**Licensing Topical Report NEDO-33268, "ESBWR Human
Factors Engineering Human-System Interface Design
Implementation Plan,"**

Revision 4

May 2009

**ESBWR HUMAN FACTORS ENGINEERING
HUMAN-SYSTEM INTERFACE DESIGN
IMPLEMENTATION PLAN**

Figure 2. Human-System Interface Design Implementation Process

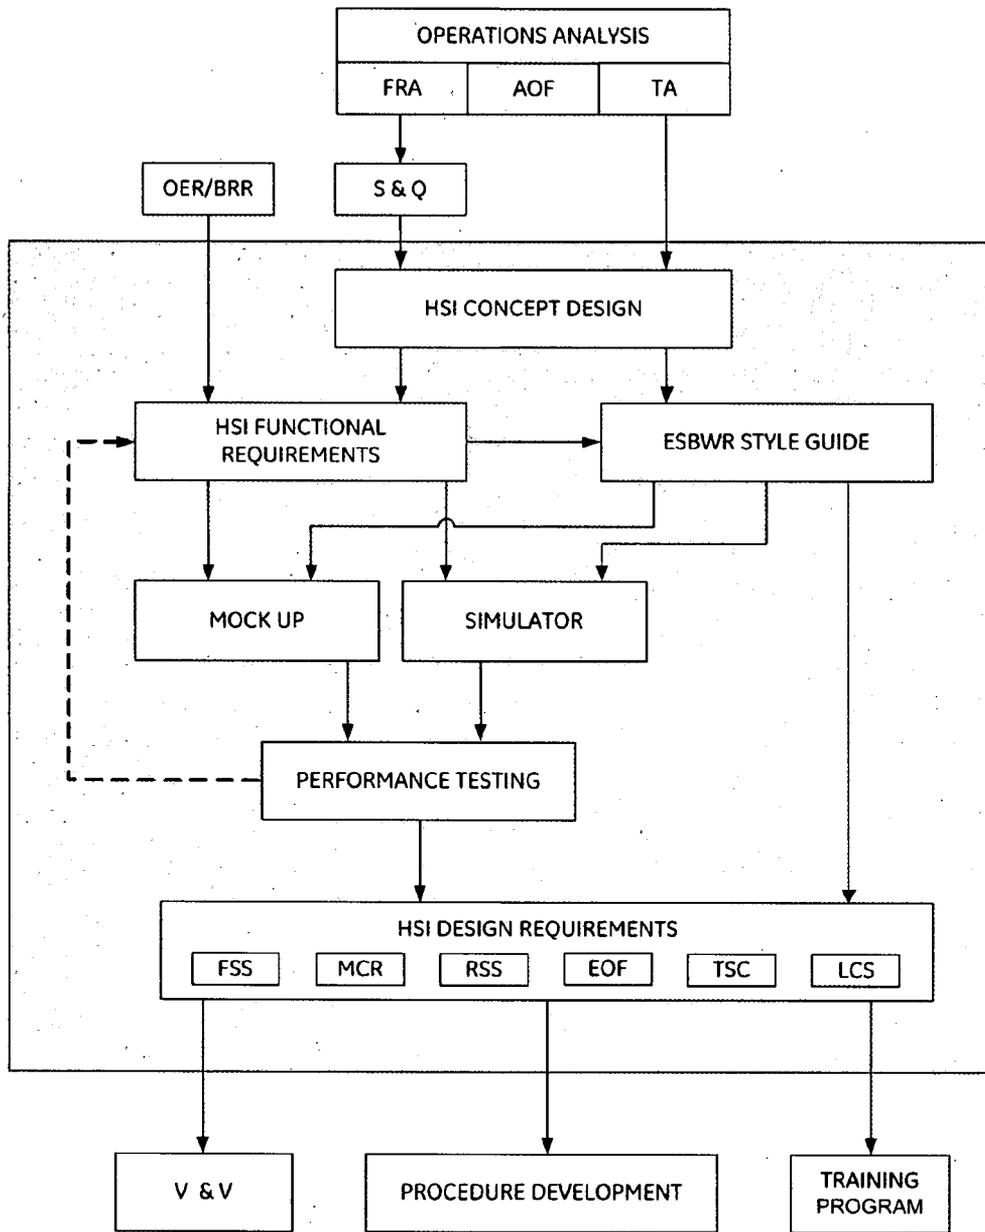
| Item | Location | Change | Comment |
|-------------|--|---|--------------------------------|
| 10. | Figure 2 | Added OER/BRR input directly to HSI. | As a result of RAI 18.8-51 S02 |
